Amendments to the Drawings

Remarks/Arguments

Appl. No. 10/810,351
Amdt. dated April 3, 2006
Reply to Office Action of October 3, 2005

FIG. 5

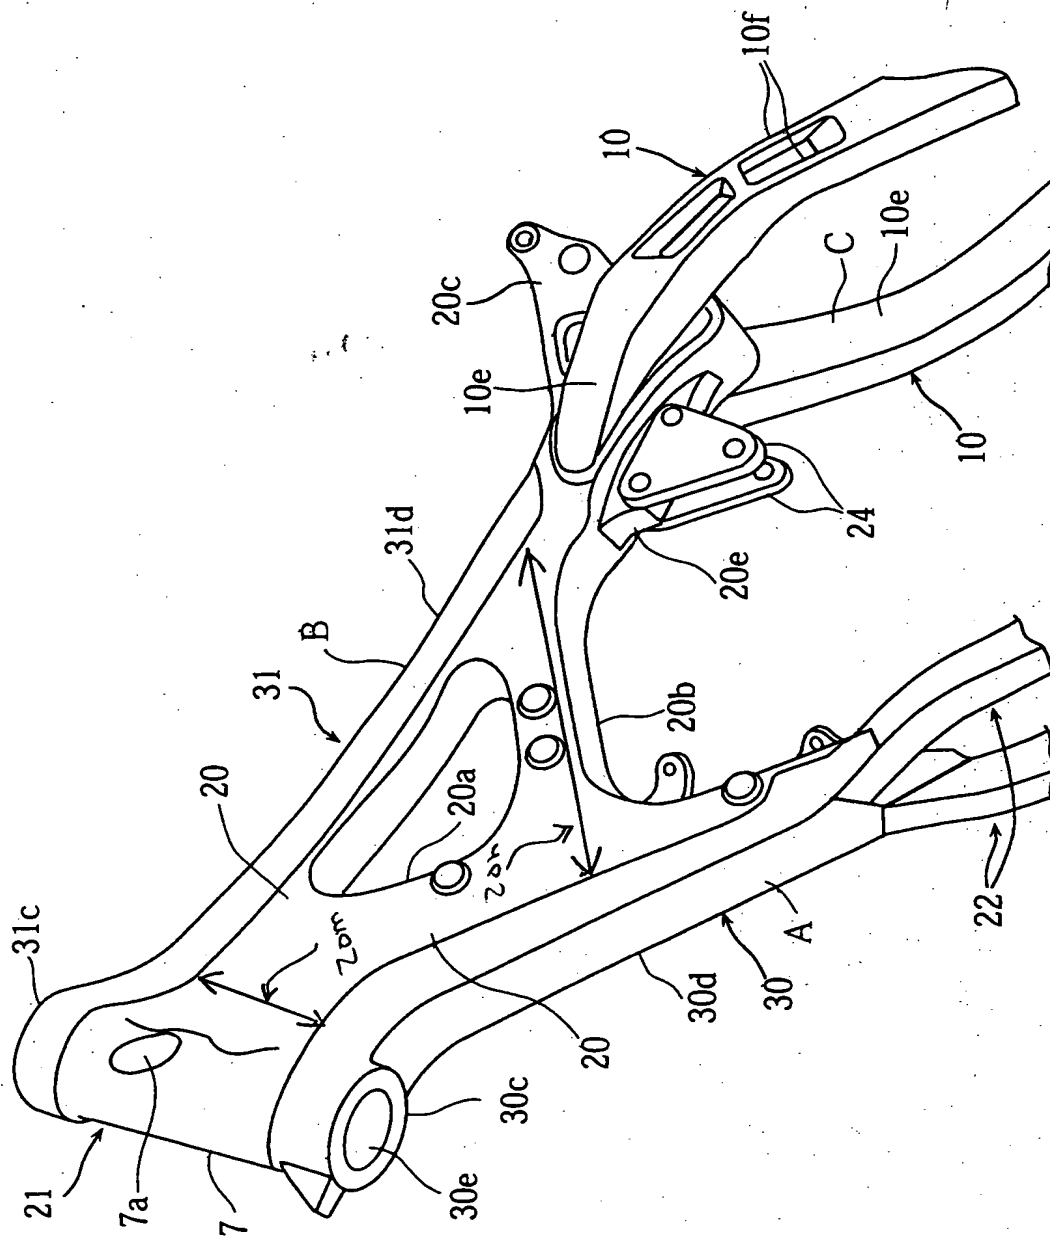
Next, the Action asserts that the gussets “widening in a rearward manner” cannot be ascertained (claims 2, 4, 12, 15-17). In response, applicant submits that this feature is shown and described in both the drawings and specification. As described in paragraph [0047] of the specification, gussets 20 widen to the rear of the vehicle from the head pipe 7. This claimed feature is clearly seen in applicant’s Figs. 1-6, where gussets 20 extend rearwardly from head pipe 7 and become wider as they extend rearwardly. It is clear, for example, that a more rearward portion of gusset 20, such as a portion of gusset 20 adjacent tension pipe 20b, is wider than a less rearward portion of gusset 20, such as a portion of gusset 20 adjacent head pipe 7. Thus, Figs. 1-6 show that the gussets widen in a rearward manner.

The attached sheets of drawings include changes to Figs. 5 and 9 and replace the original sheets including Figs. 5 and 9. In Fig. 5, reference characters 20m and 20n are added to indicate a respective narrower width 20m and wider width 20n of gusset 20. In Fig. 9, reference characters 21b and 21c are added to indicate openings 21c in lower undersurfaces 21b of gusset 20, and reference characters 21d and 21e are added to indicate openings 21e in top surfaces 21d of gusset 20.

In order to clarify this feature, Fig. 5 of the drawings is amended to indicate that gussets 20 have a narrower width 20m adjacent head pipe 7 and a wider width 20n as gussets 20 extend rearwardly from head pipe 7. Paragraph [0047] of the specification is similarly amended for consistency. In addition, the claims are amended to clarify that the gussets widen “...in a rearward manner *from the head pipe...*”.
